SR 105/US 441 Business
Interchange Widening Improvements
STP-2640(10), P.I. 132100
Habersham County, Georgia

Value Engineering Study Report
Preliminary Design Stage

January 2008

ALT TS-1
SHT 2 OF 8

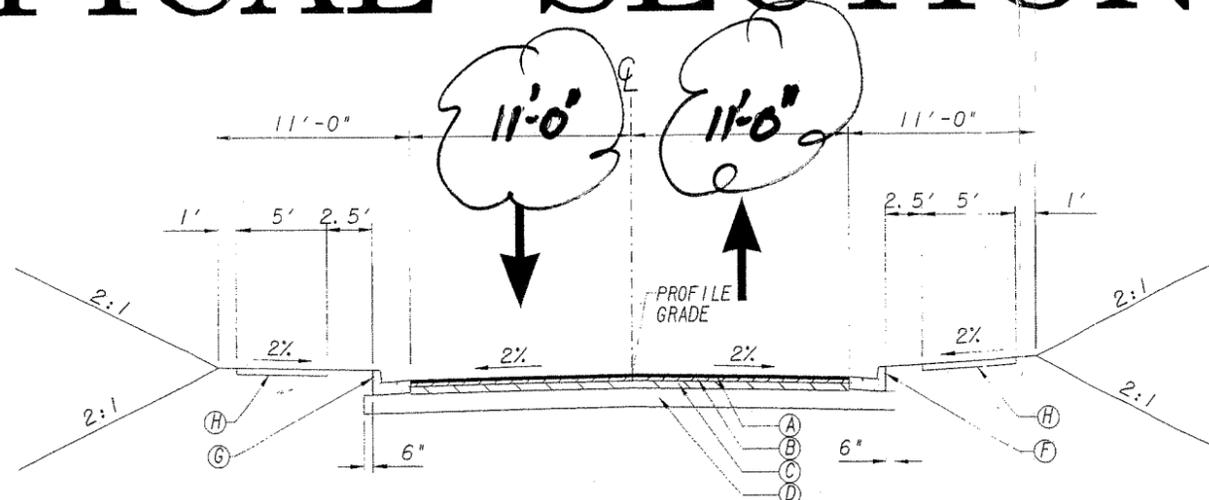
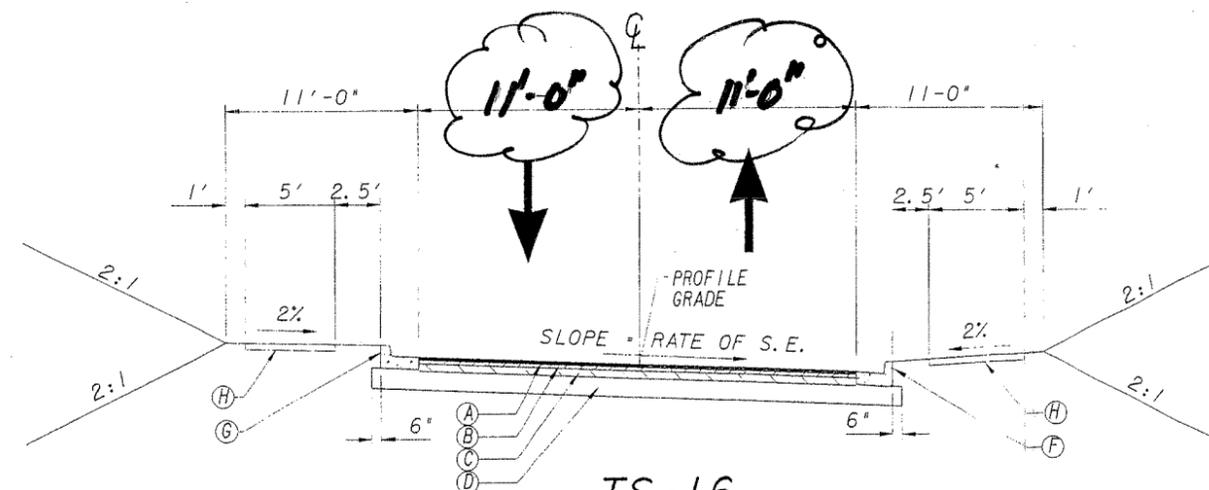
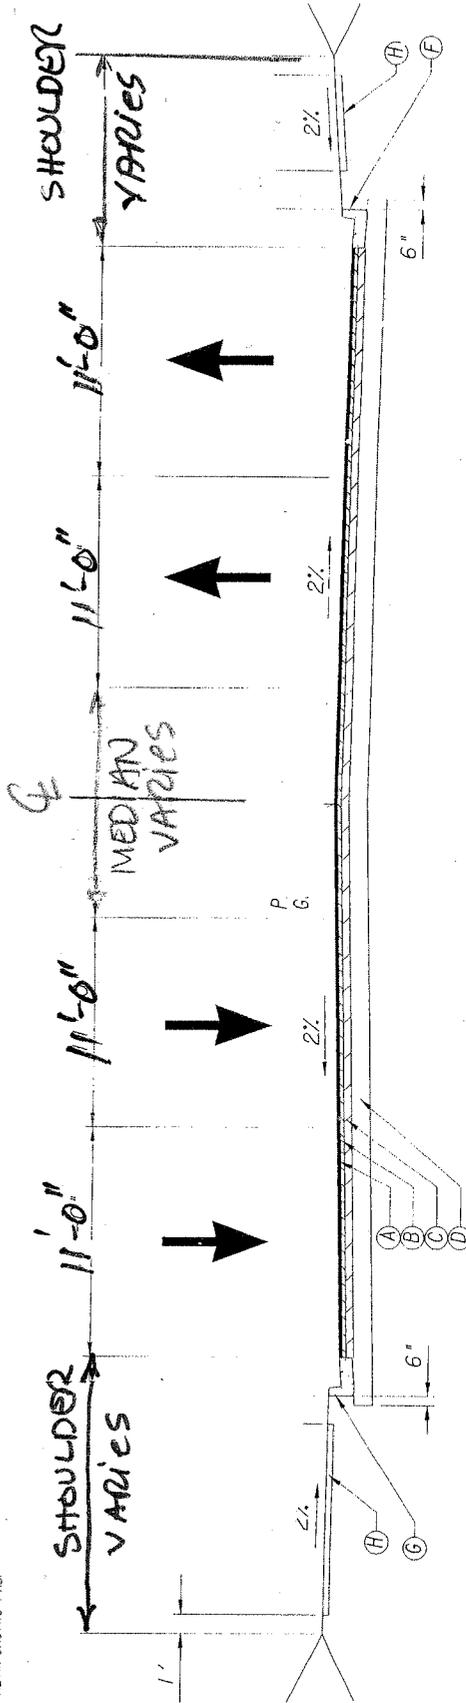
GDOT should consider using 11-ft. lanes to provide a reduction in construction and right-of-way cost. Using 11-ft. lanes in the project will provide a more consistent typical section in construction.

ALT TS-2
SHT 2 OF 5

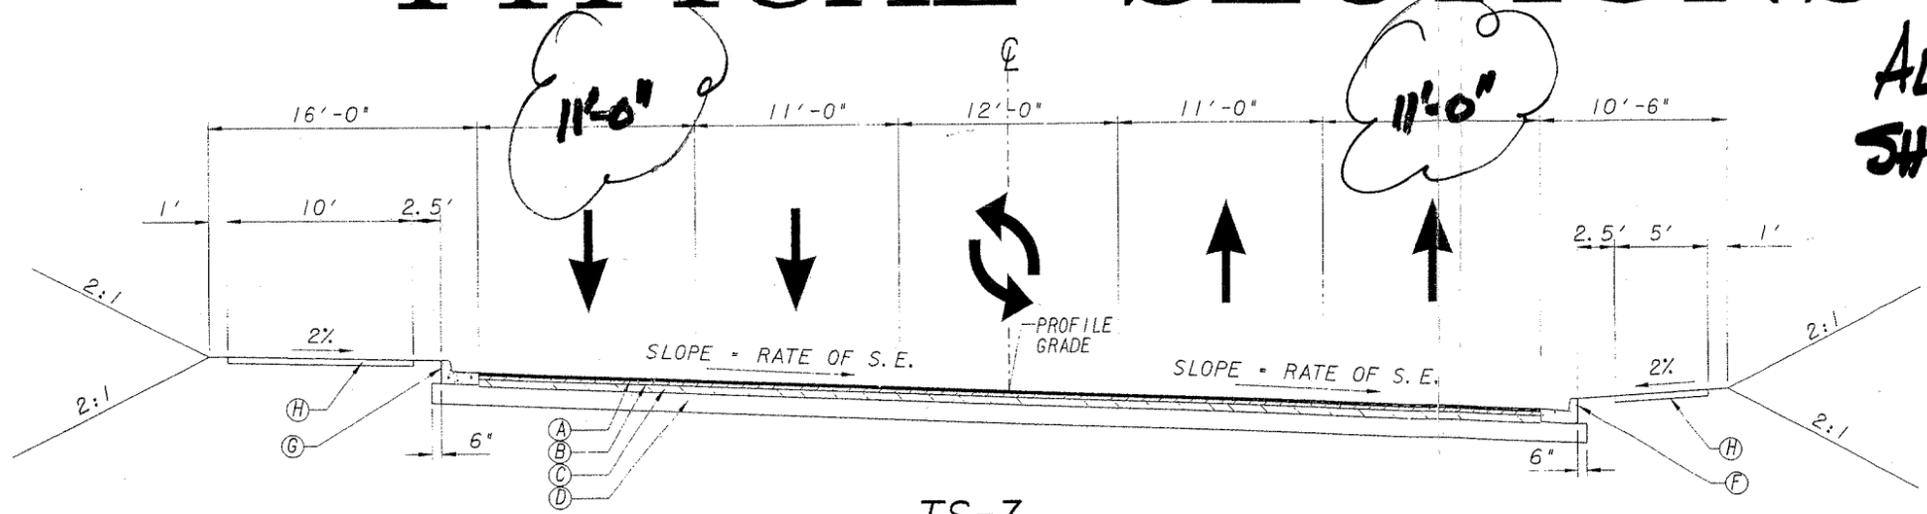
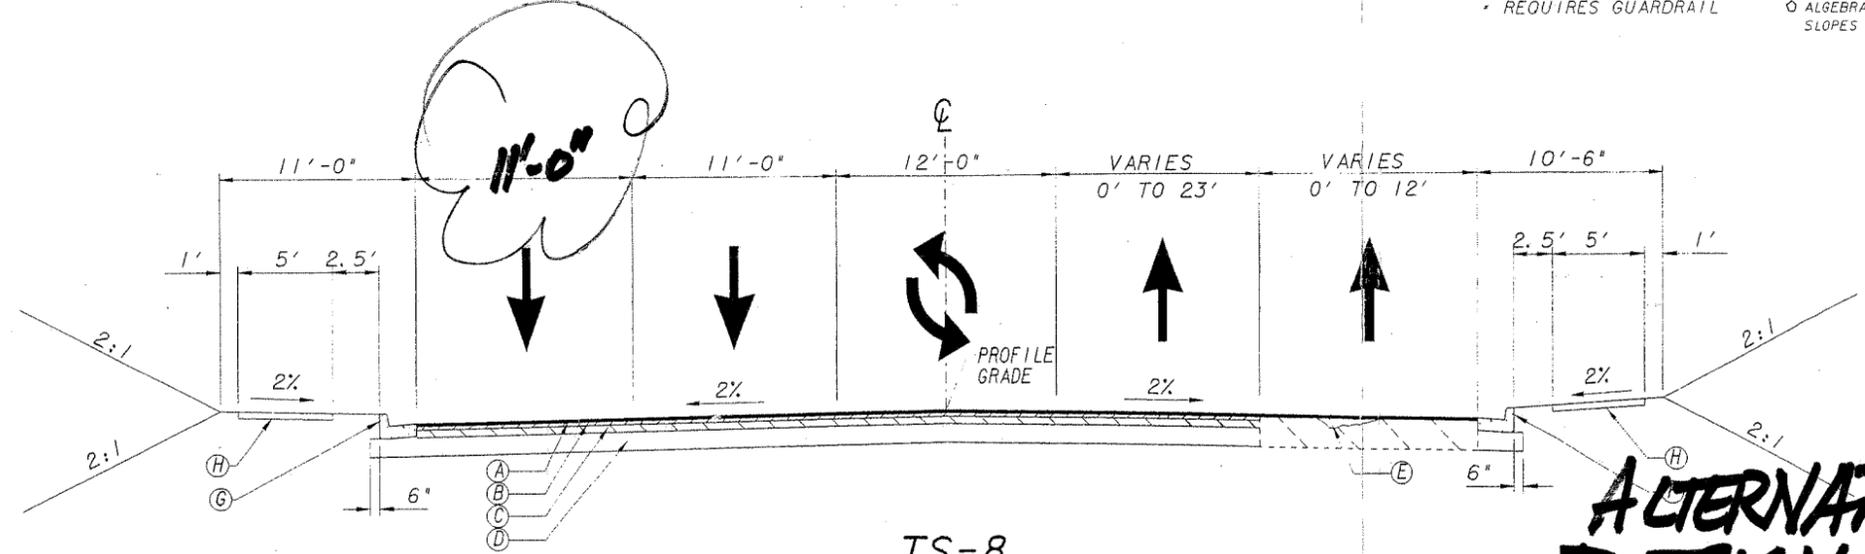
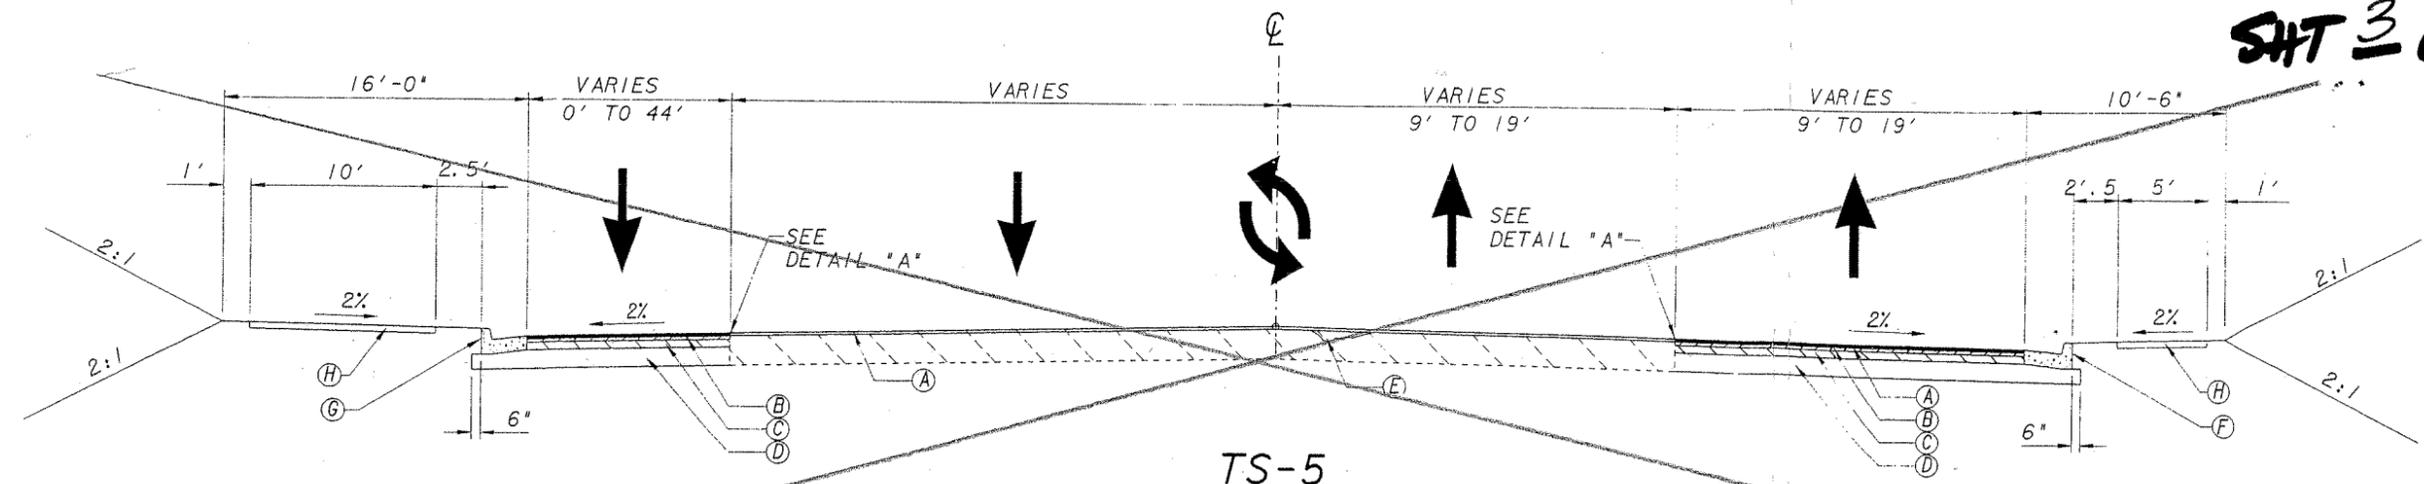
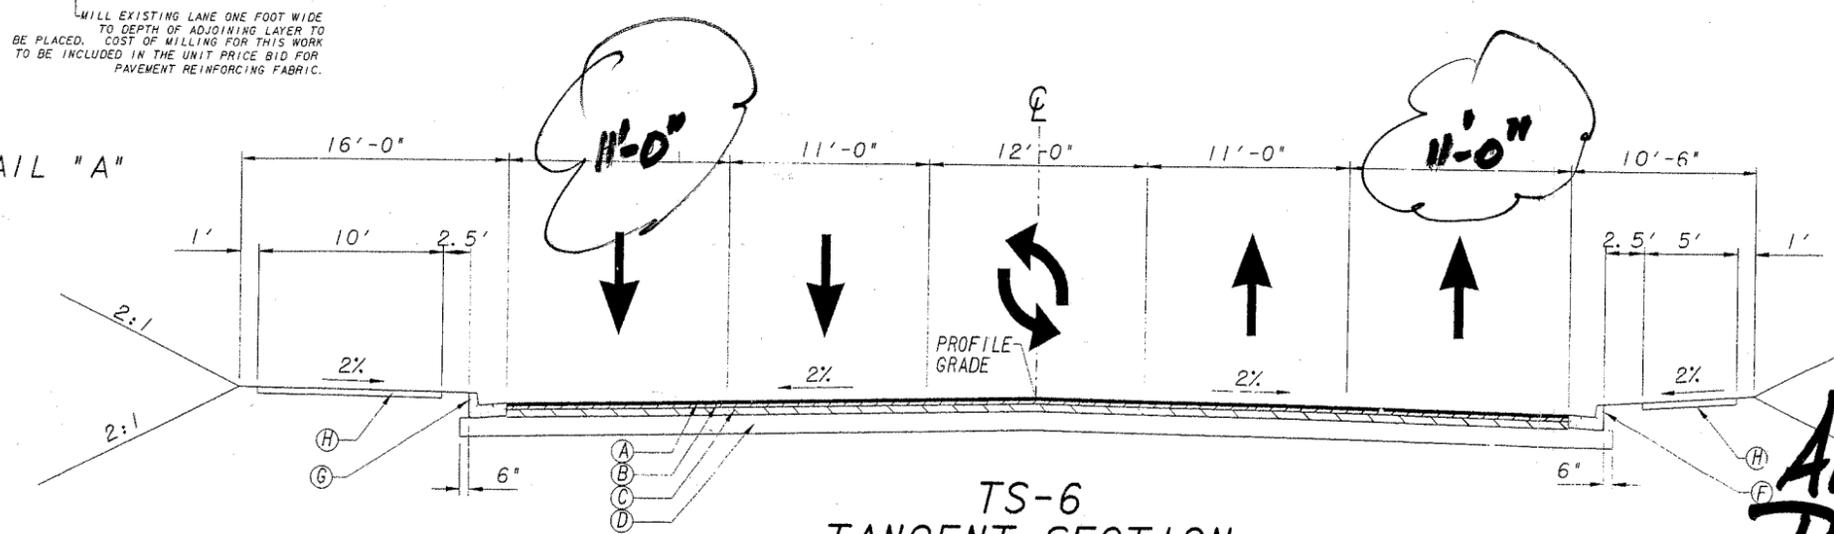
DESCRIPTION: **PROVIDE 11-FT. THROUGH LANES WITHIN THE TOWN OF CORNELIA** SHEET NO.: **1 of 5**

DESCRIPTION: **CHANGE SR 105 CURB AND GUTTER SIZE TO 8 IN. X 24 IN.** SHEET NO.: **1 of 2**

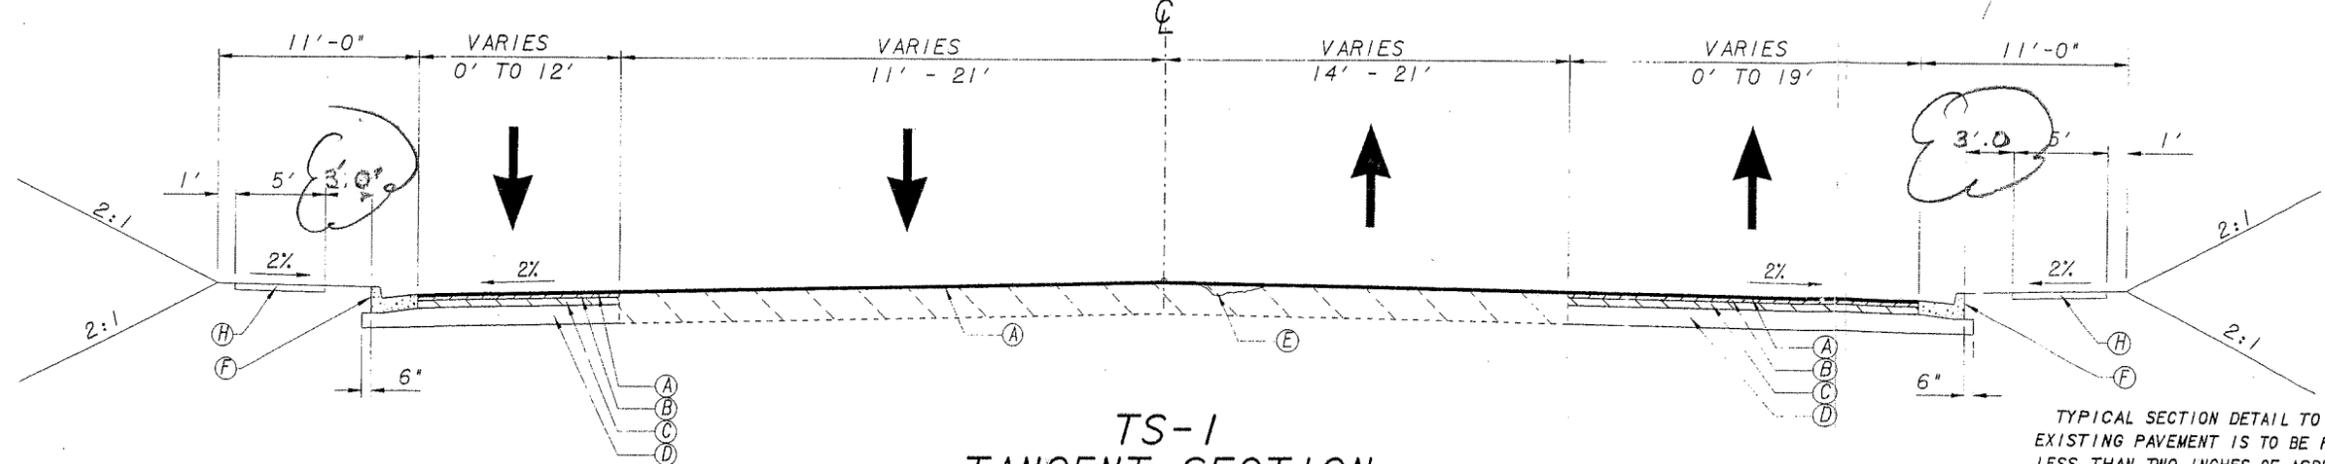
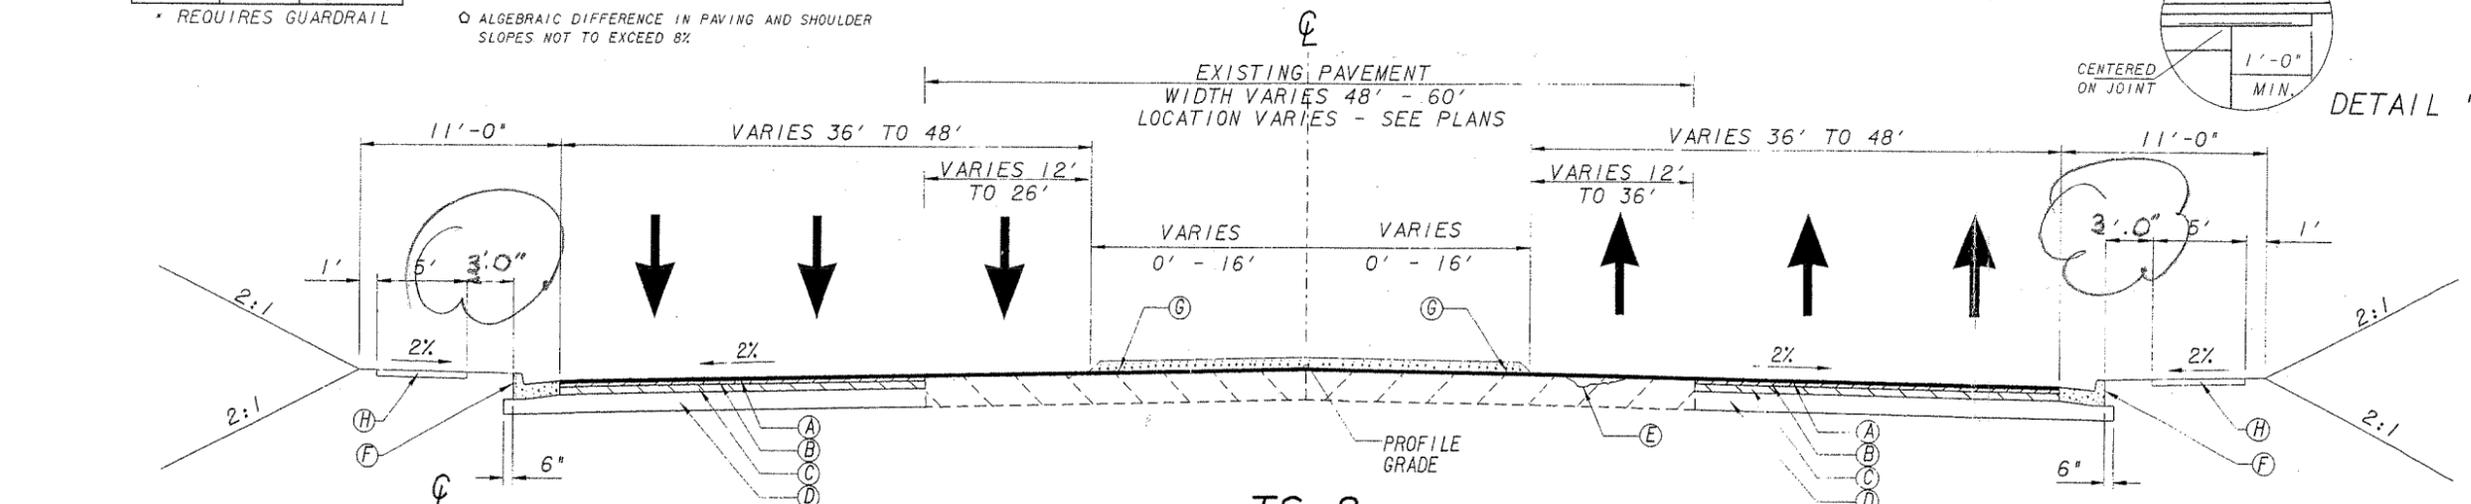
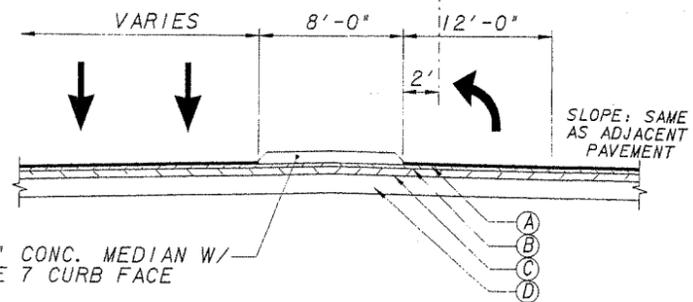
Historically, GDOT has not reaped unit price savings in the reduced curb and gutter sizes, however as the curb and gutter are extruded, the cost savings should be related to the volume per linear foot of gutter.
